2012 INDUSTRIAL PARK IMPROVEMENTS
PROJECT NO. 0959ST
CITY OF DULUTH

**ADDENDUM #2
2012 INDUSTRIAL PARK IMPROVEMENTS
CITY OF DULUTH
PROJECT 0959ST
BID NUMBER 12-0334
JUNE 19, 2012**

ATLAS INDUSTRIAL PARK IMPROVEMENTS

CONSTRUCTION PLANS FOR: ROADWAY AND UTILITY IMPROVEMENTS.

PLAN & PROFILE - NORTH CUL-DE-SAC
 SHEET No. PP09

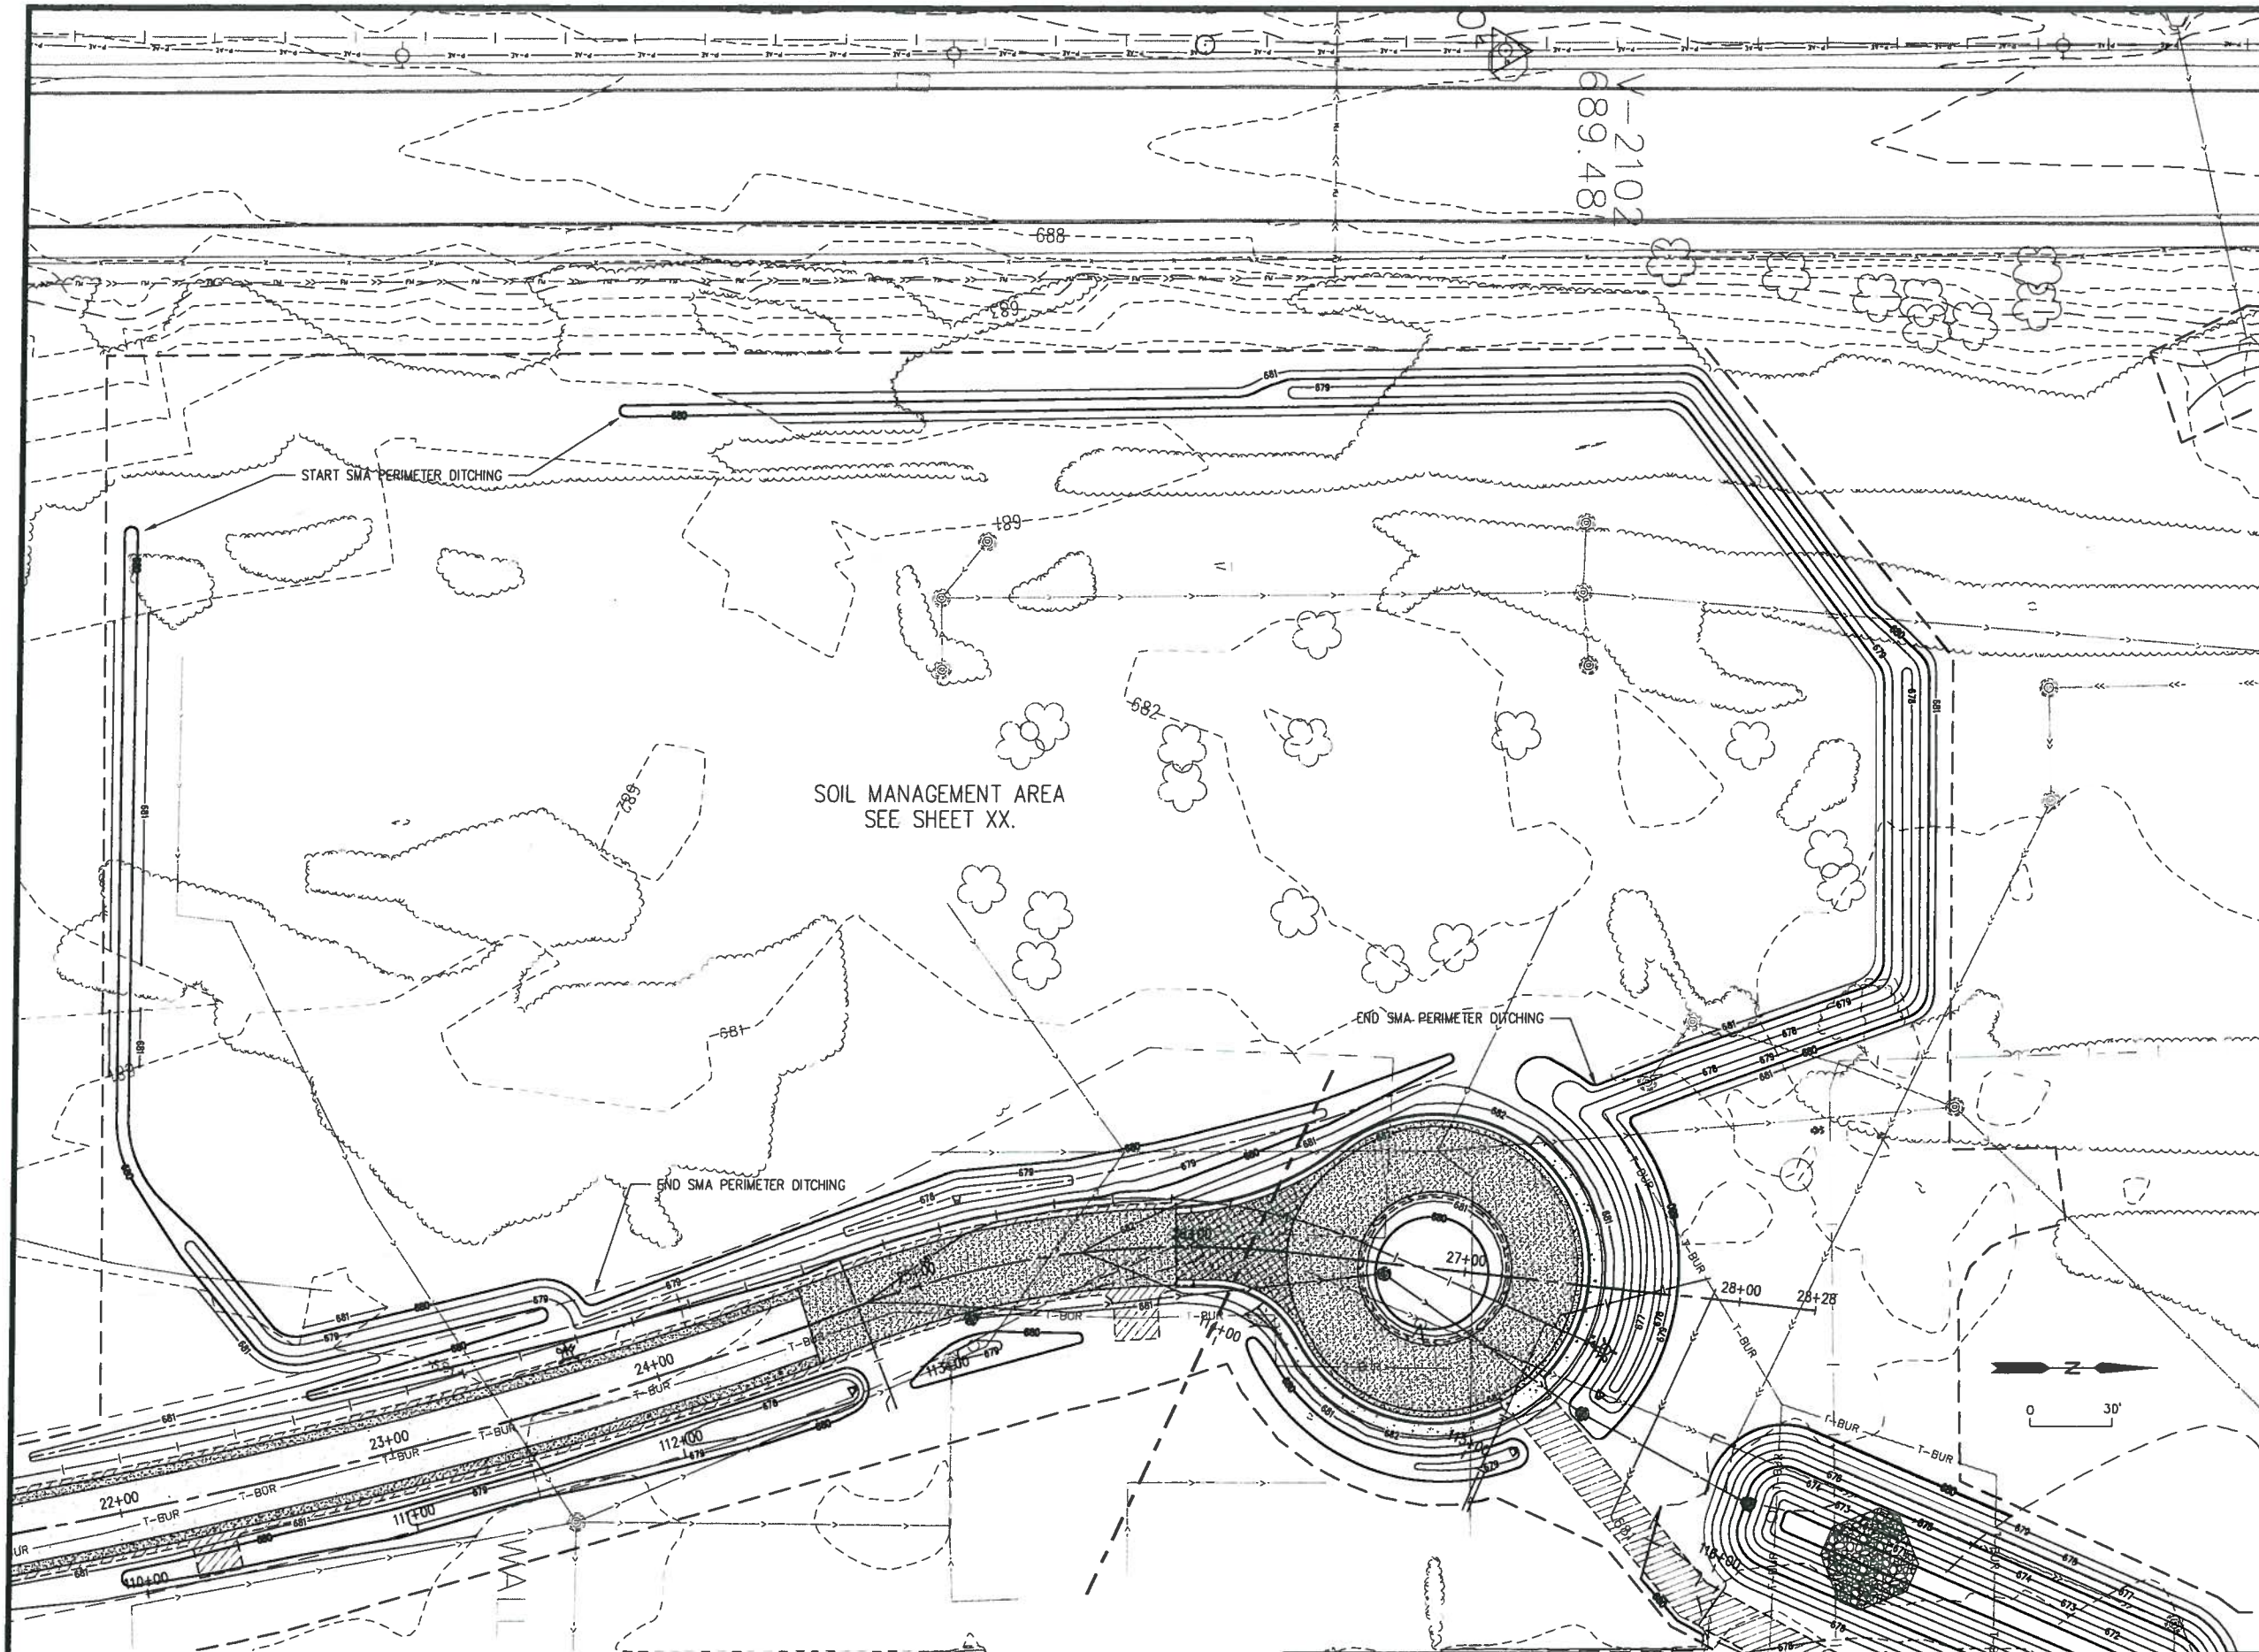
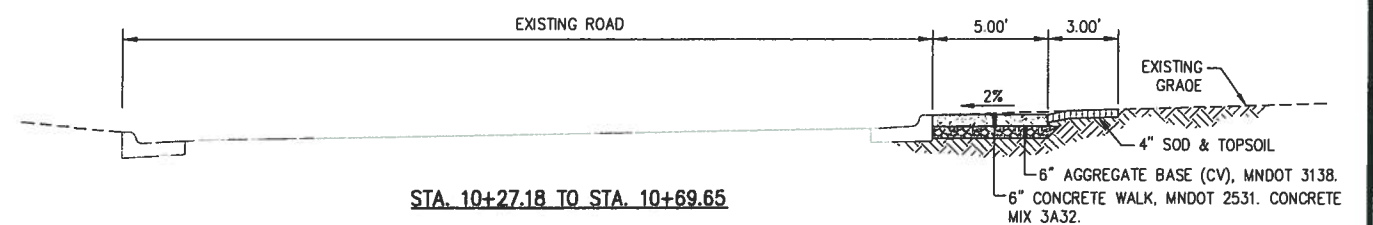
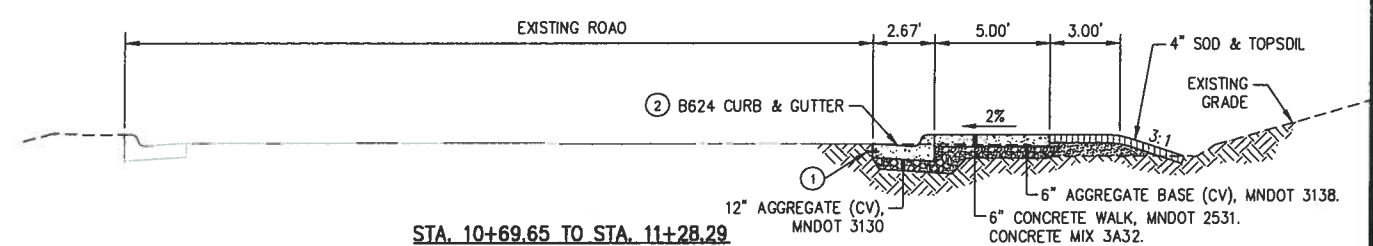
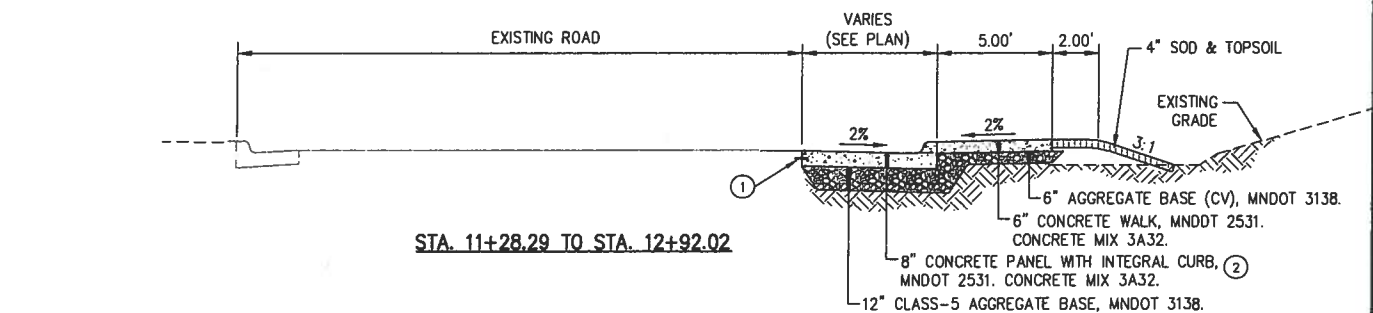
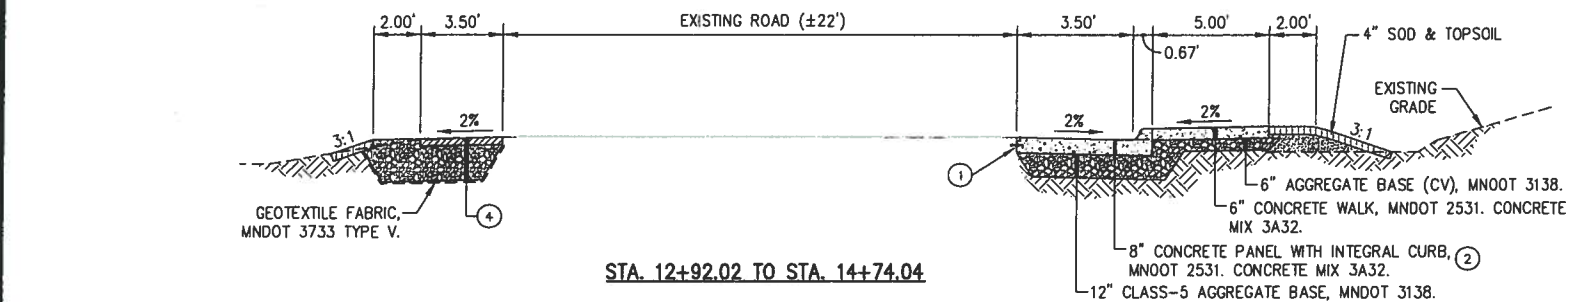
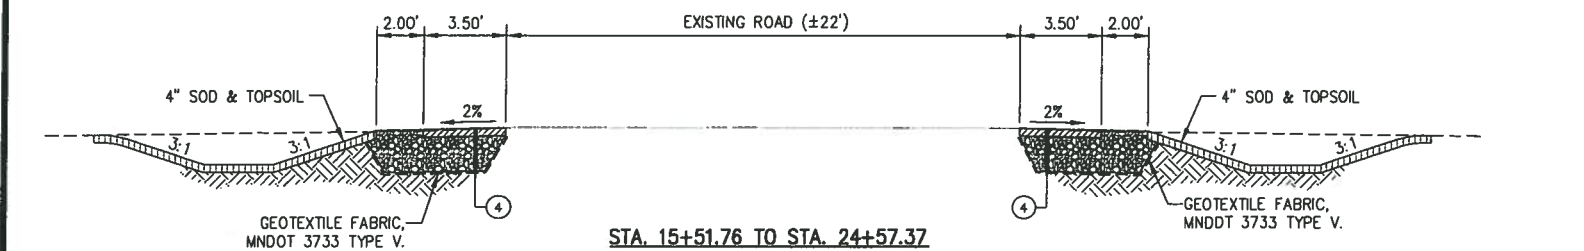
1. Eliminate all sidewalk on the cul-de-sac on the north end of Nick Glumac Drive
2. Provide perforated subdrains around the cul-de-sac island at the end of Nick Glumac Drive. Connect subdrains to PCB 35. The pavement in this cul-de-sac is sloped to the center and the subgrade slope shall match the slope of the pavement.
3. On plan sheet DM1-DM3, delete part of Note 2, which states "ALL AREAS DISTURBED SHALL BE RESTORED PER SWPPP.", replace with, "ALL AREAS DISTURBED SHALL BE RESTORED WITH 4" OF TOPSOIL BORROW (MnDOT 3877), MnDOT SEED MIX 250 AT 70 LBS/AC AND MULCH TYPE 1 OR 3 AT 2 TONS PER ACRE. EROSION CONTROL BLANKET WILL BE REQUIRED IN PLACE OF MULCH ON SLOPE 1:3 (v:h) OR GREATER AND ALL DITCH BOTTOMS AND EXTENDING 12" VERTICALLY UP THE SIDES PERPENDICULAR FROM THE DITCH BOTTOM."
